ADDENDUM NO. 2

Furnace Bridge - Installation

Essex County, NY

July 29, 2015

DRAWING NO. **C-5** SHT. 5 OF 5
REV. 0

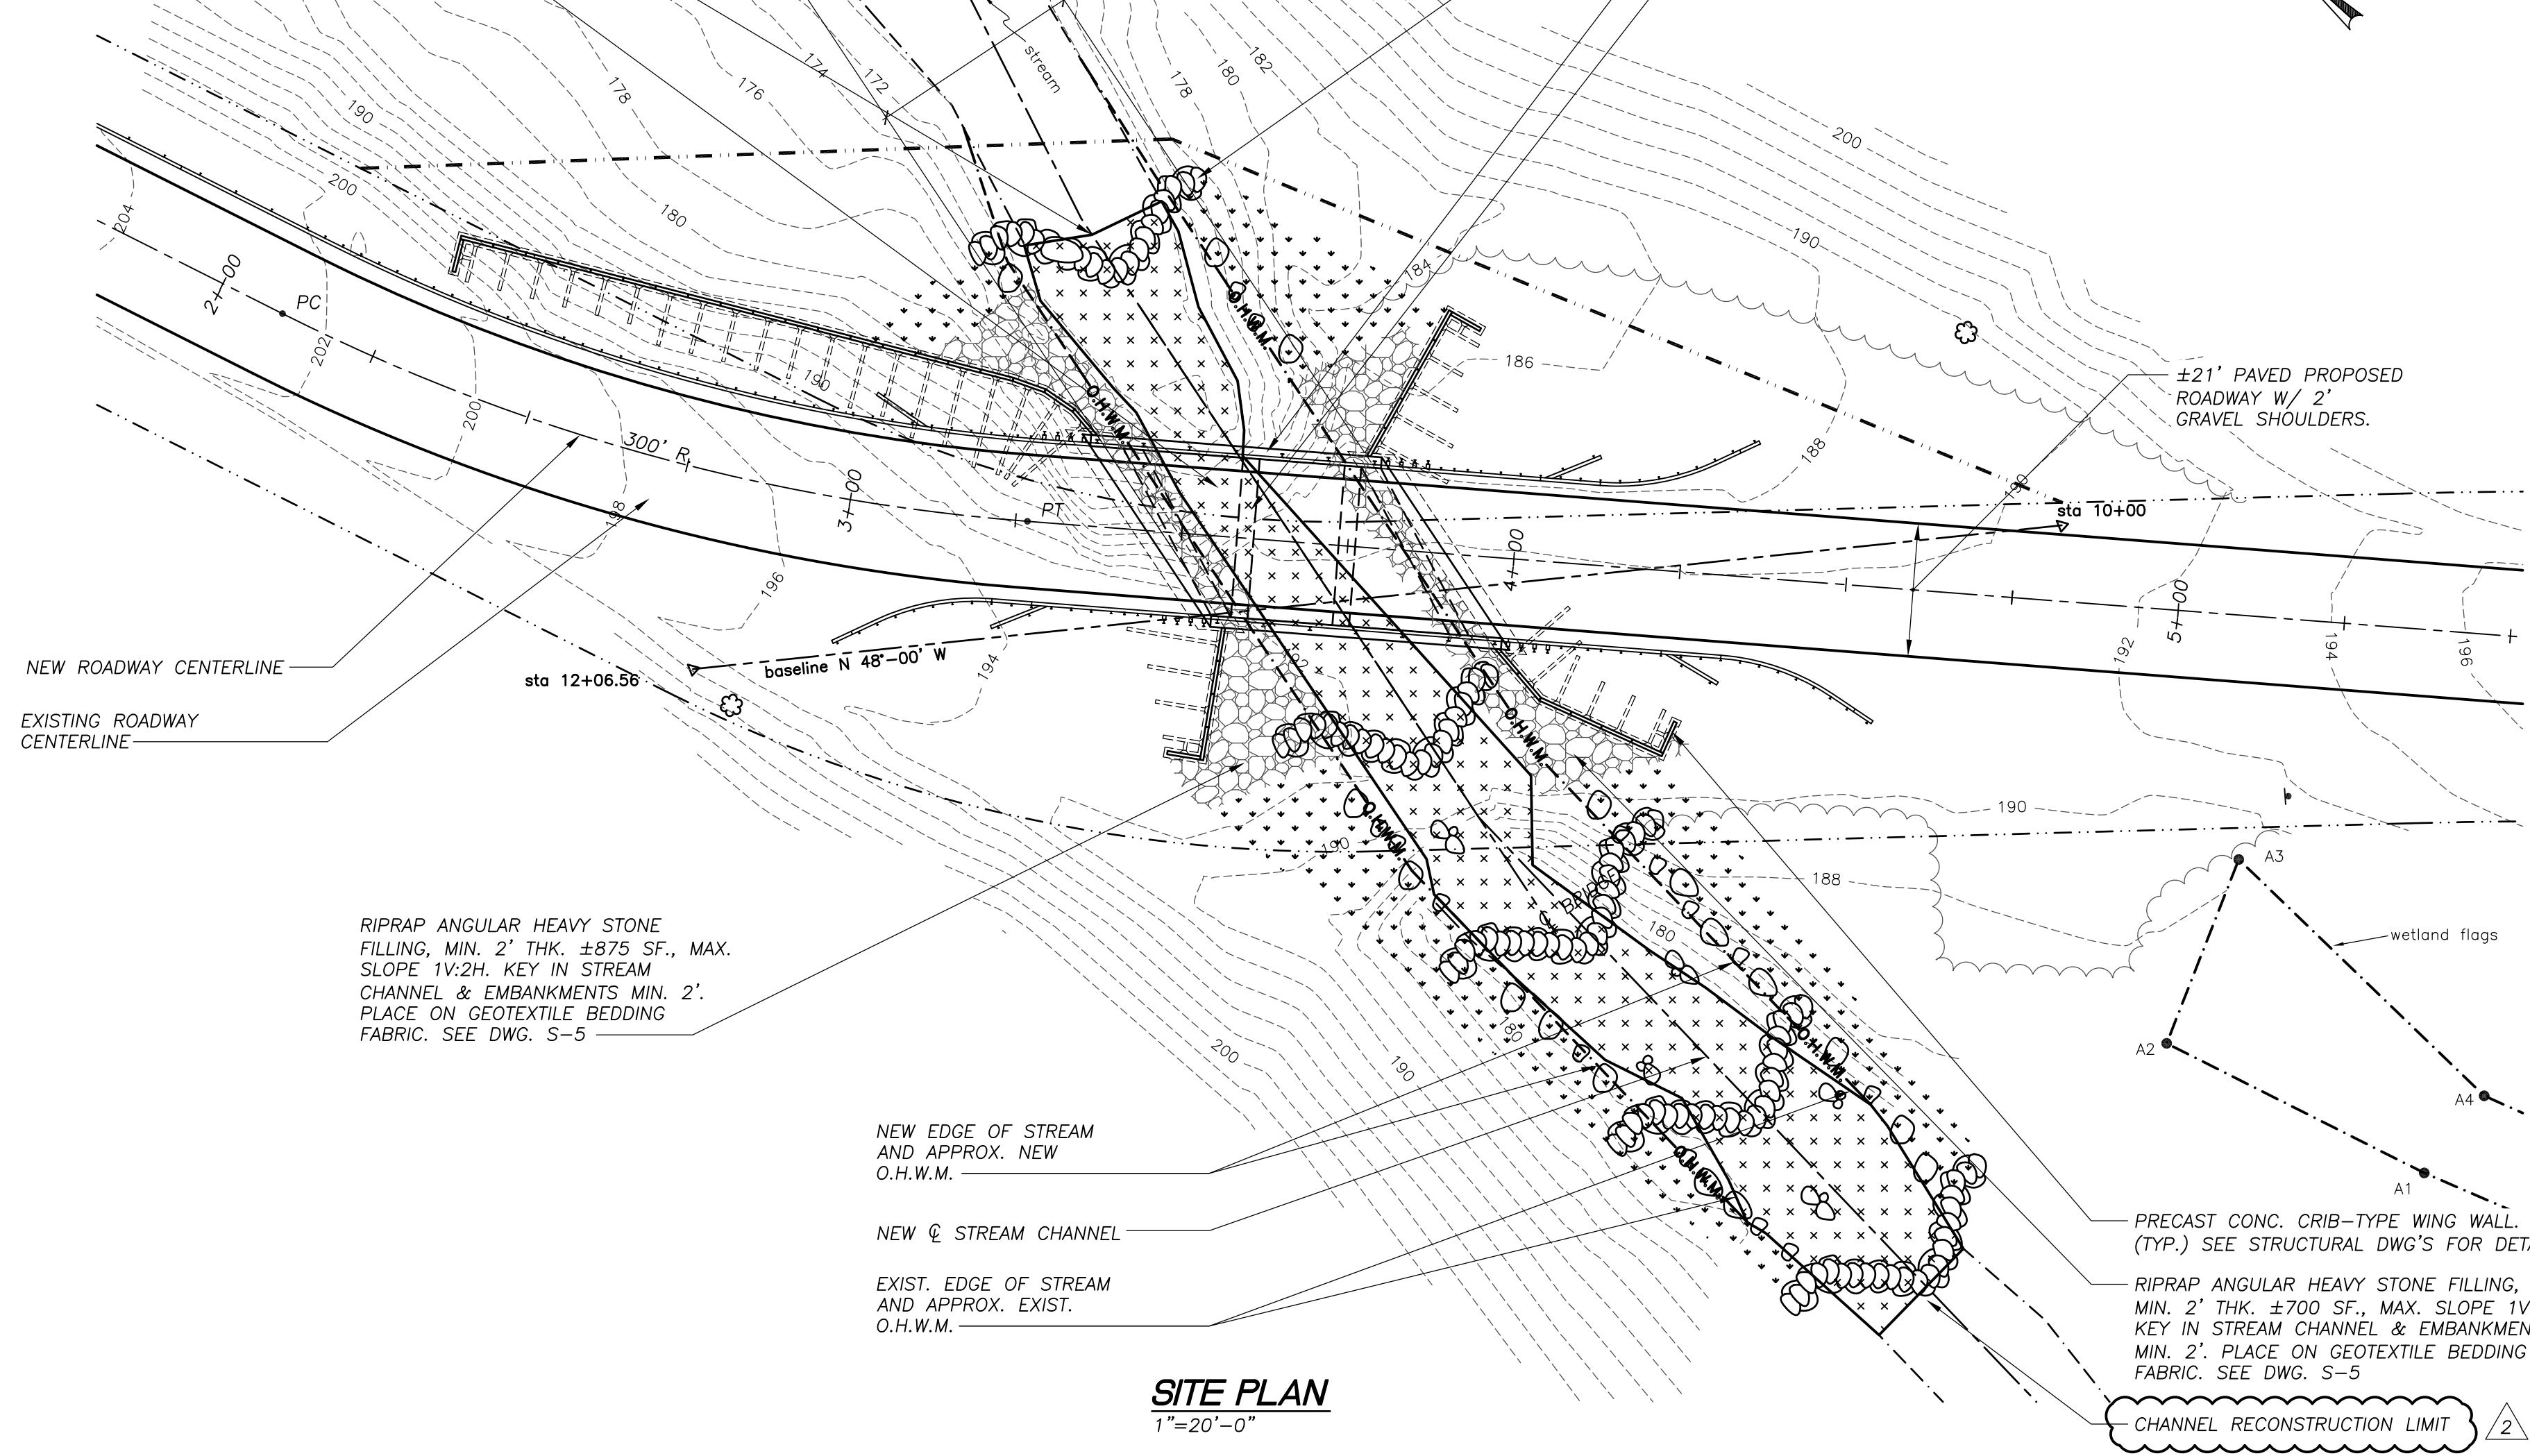
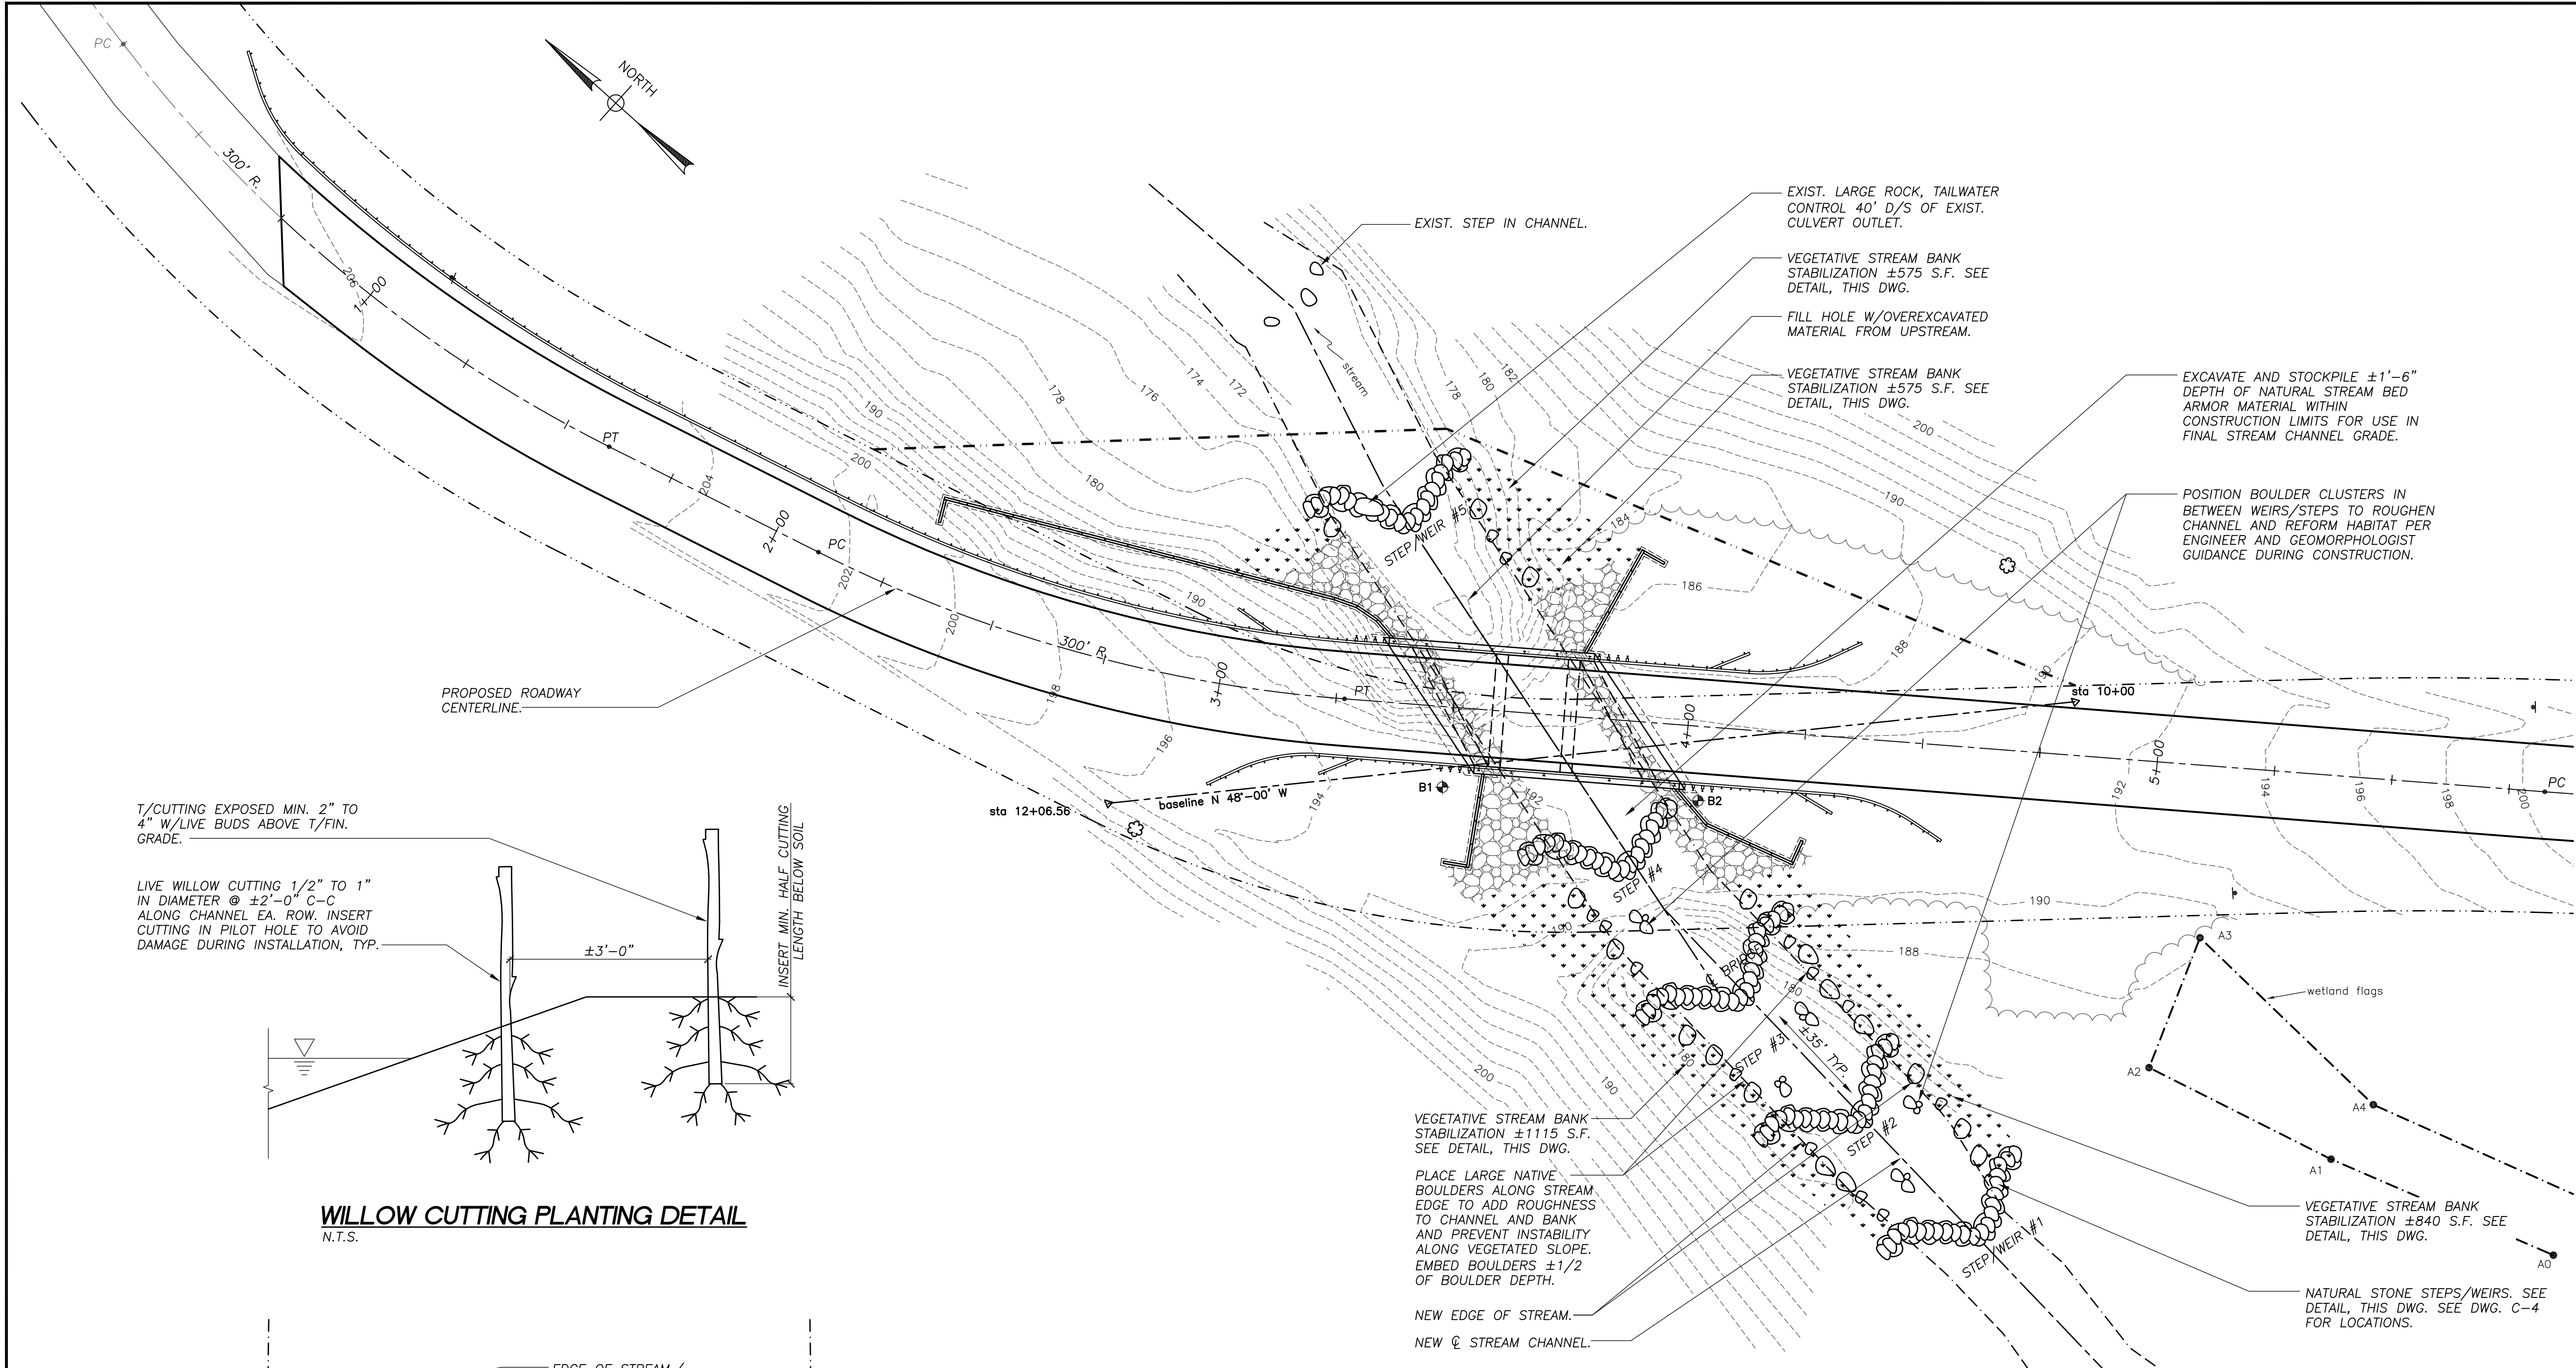
5. **General:** As noted in the Pre-Bid Meeting Minutes included in Addendum No. 1, modifications have been made to the stream channel reconstruction from the information currently indicated on the bidding documents. DELETE the drawing Cover Sheet and Drawing Nos. N-1, C-1 through C-4 and COE-1 and SUBSTITUTE THEREFORE the attached Cover Sheet and Drawing Nos. N-1, C-1 through C-5 and COE-1, all bearing the Revision date 7/29/15 and designation "Issued with Addendum 2". Bidders shall include all costs for the stream channel reconstruction work in their Bid for the project.
